SERVICE DIRECTIVE BULLETIN NO. 0111 Revision 2

1. SUBJECT: Tail Rotor Driveshaft and Tach Drive Pulley Guard Inspection

2. MODEL: F-28A, 280, F-28C, F-28C-2, F-28C-2R, and 280C

Figure 1. Pulley Guard Optional Modifications

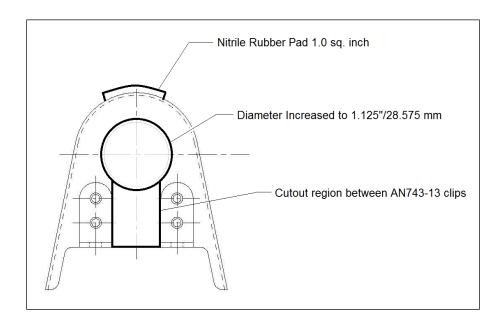
<u>NOTE</u>: Refer to IPC Figure 12-4 and Figure 1 for the following modification steps.

- A. The modification removes material between the clips of the pulley guard to simplify maintenance operations pertaining to the rotor tach assembly or the tail rotor driveshaft and increases the hole diameter to add clearance between the driveshaft and the pulley guard. This modification may be performed with the rotor tach assembly left intact.

- 2) Using a suitable metal cutting tool, cut out the area of the pulley guard between the clips.
 - 3) Remove the pulley guard by slipping it off the driveshaft via the cutout area. Avoid scratching the driveshaft. It will be necessary to twist the guard to provide additional clearance with the driveshaft.

- 4) The pulley guard hole may be machined to a maximum 1.125 inch/28.575 mm diameter.
 - 5) Deburr and apply corrosion protection to all newly cut surfaces.

- B. If there is evidence of contact between the upper cowling and the pulley guard, install a Nitrile rubber pad, or equivalent, on top of the pulley guard to provide surface abrasion protection and vibration dampening properties. Note: Select either a 1/16 inch/1.58 mm or 1/8 inch/3.17 mm to match the gap distance between the pulley guard and the cowling. A one square inch piece will be adequate.

- 1) Remove the pulley guard attachment hardware (310, 320) and fitting (140) and slide guard (30) forward for access. Note the placement and number of washers used for shimming.

- 6) Reinstall the pulley guard hardware (310, 320) and fitting (140). Reinstall any shims.
 - 7) Check the pulley guard clearance with the driveshaft and the pulley belts. Adjust the number of shimming washers, if necessary.

- 1) Remove contamination from the pulley guard surface with a clean shop rag wetted with an appropriate solvent. Allow to dry.
 - 2) Install the rubber pad with Loctite 4212 adhesive, or equivalent.
